Stage 3 Facilities, Sydney Business Park **Response to Submissions**

November 2020

PJEP Ref: SBP Stage 3 Facilities_RTS_Nov20

A comparison of the Stage 3 Master Plan as originally proposed in the EIS, and as revised in this RTS, is shown on **Figures 1 and 2** below. As illustrated, the proposed changes to the proposed development are minor in nature.

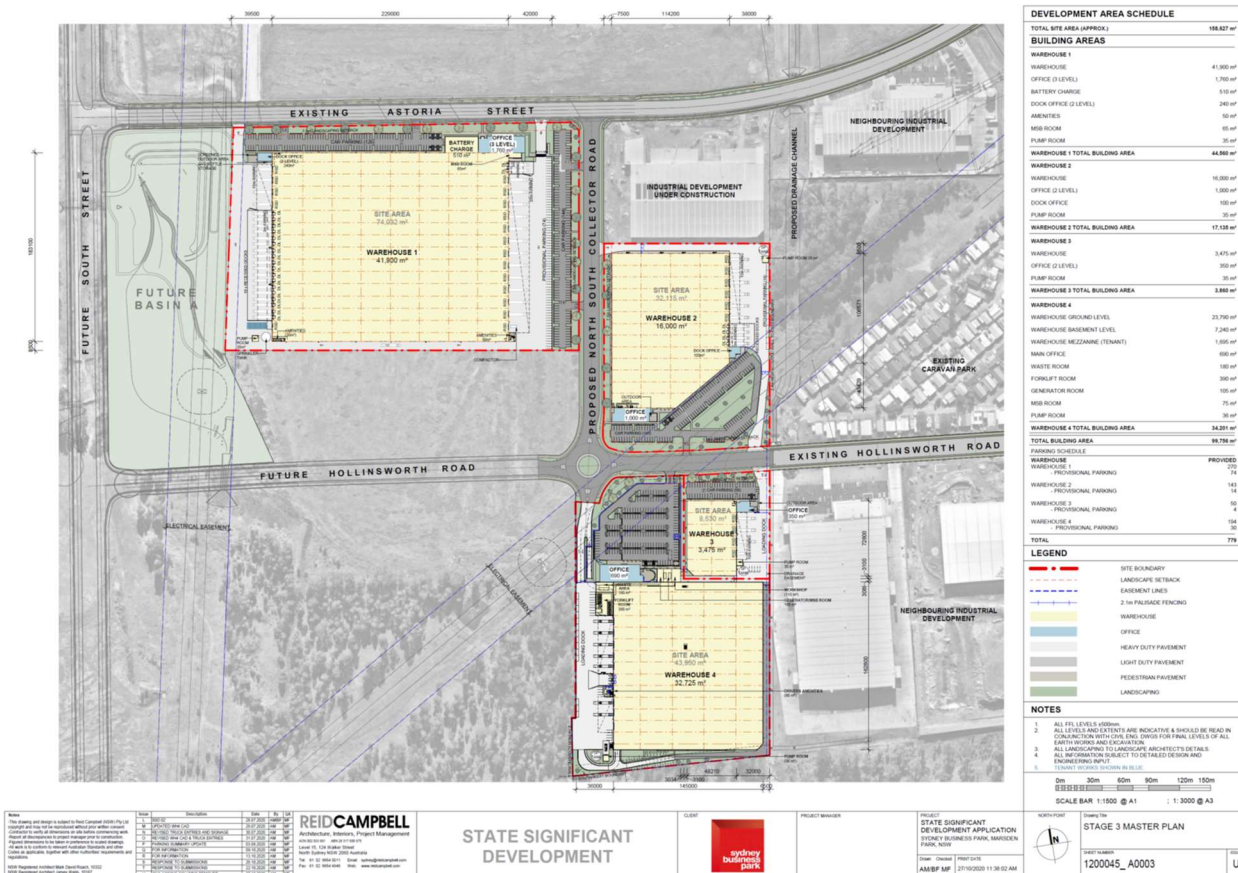
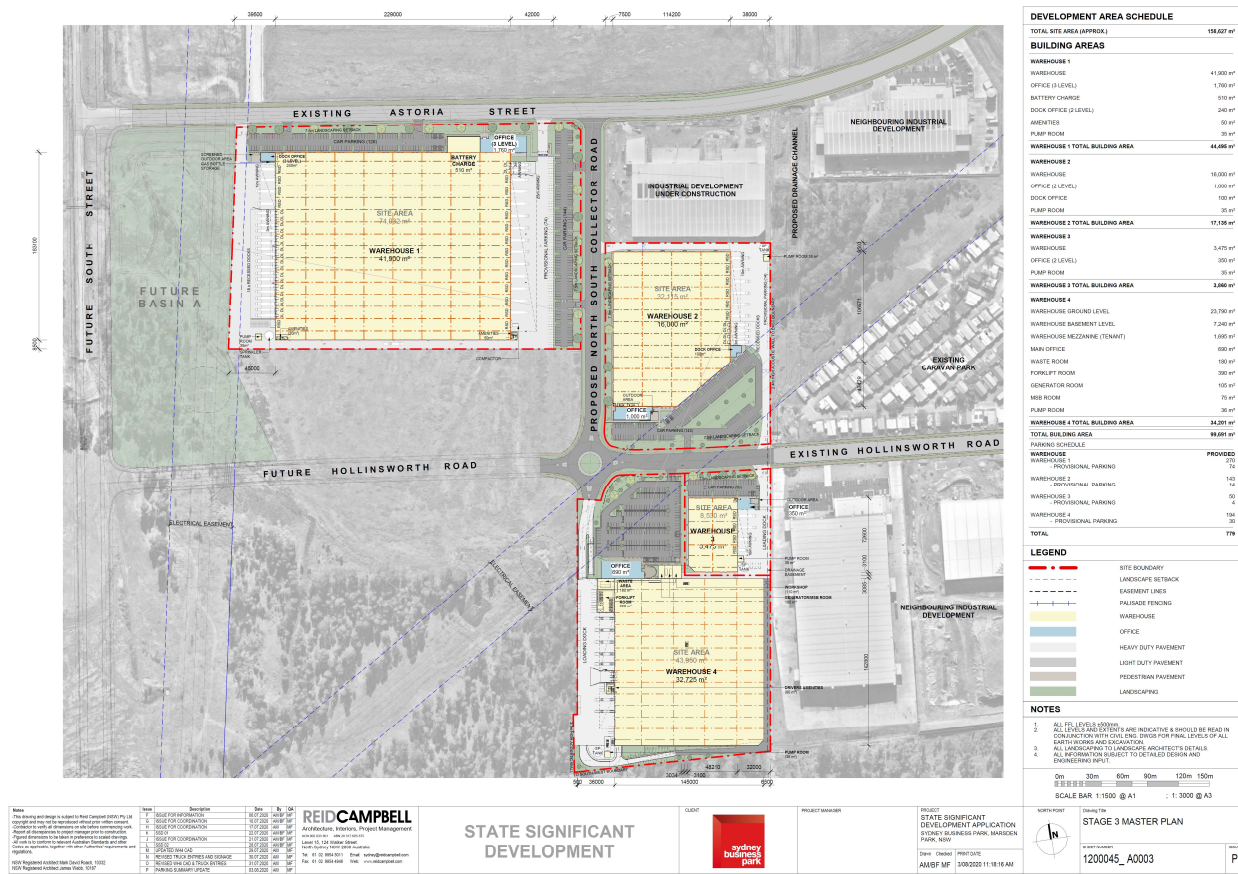
- relocation of the truck exit driveway for Warehouse 2 to provide additional landscaped setback to the caravan park, along with associated minor changes to the car park layout;
- additional landscaping in the southern area of Warehouse 4 (API Facility), and in the shared area between Warehouse 4 and Warehouse 3;
- additional pedestrian pathways and/or line marking for Warehouse 1 and Warehouse 2;
- minor changes to the streetscape landscaping, including street trees at 8 metre spacings, and amendment of the street tree species for the collector road to *Angophora floribunda*;
- changes to the stormwater management strategy for the development, including site regrading and earthworks, stormwater drainage pipework changes, stormwater treatment device changes and changes to rainwater tank sizes (see response to Council item 2 for further detail);

- addition of a switch room (65 m²) on the southern side of the ancillary office for Warehouse 1 (TJX Facility);
- reduction in the width of the eastern loading dock awning for Warehouse 1, from 25 metres to 20 metres; and
- amendments to the internal ancillary fitout for Warehouse 1.
